THE TOWN HALL TROWBRIDGE

TITLE
Planning - Proposed Roof - LBC Amendment

DRAWING NUMBER
241552-PUR-01-RF-DR-A-0204a

2 Proposed Roof Interventions - AS PROPOSED
1 : 100

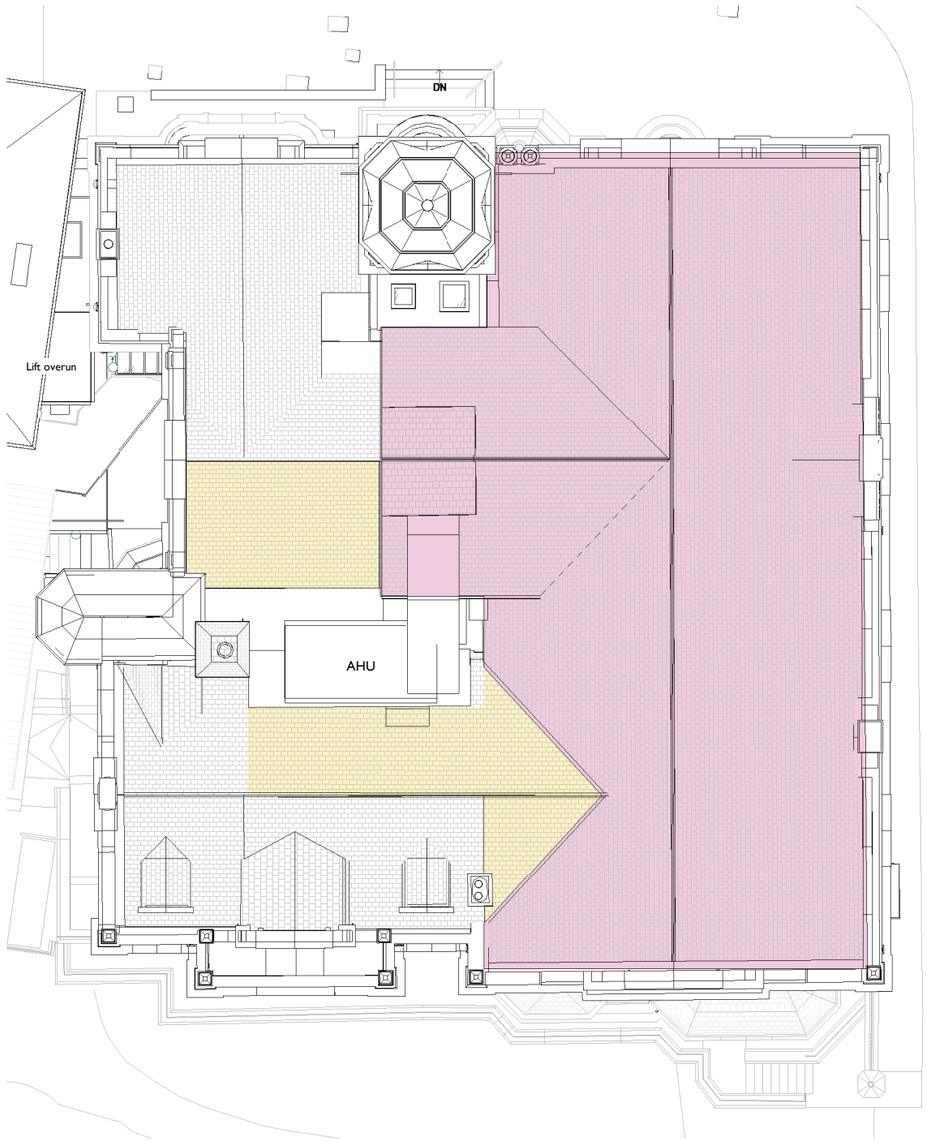
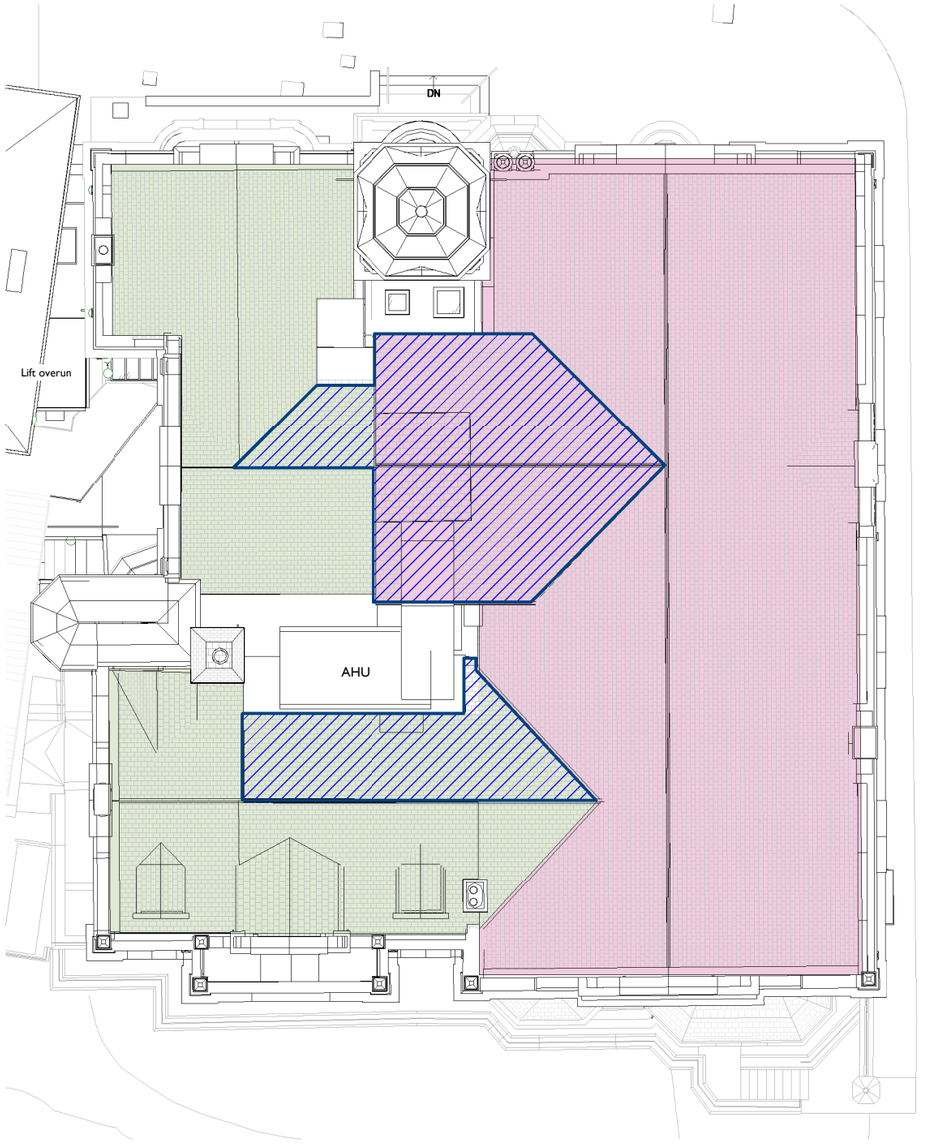
Roof line to be raised slightly to have mineral wool insulation between and above the existing rafters. Outer layer of insulation to be sandwiched between two dense boards. Slates to be removed and reinstated over new roof build up. New slates to match exiting as required. New internal timber boards to match existing.

Roof line to be raised slightly to have mineral wool insulation between and above the existing rafters. Slates to be removed and reinstated over new roof build up. New slates to match exiting as required.

Slate tiles to be carefully stripped back to ridge line to allow for upgrades to adjacent flat roof (future AHU location).

Proposed location of 508mm slates
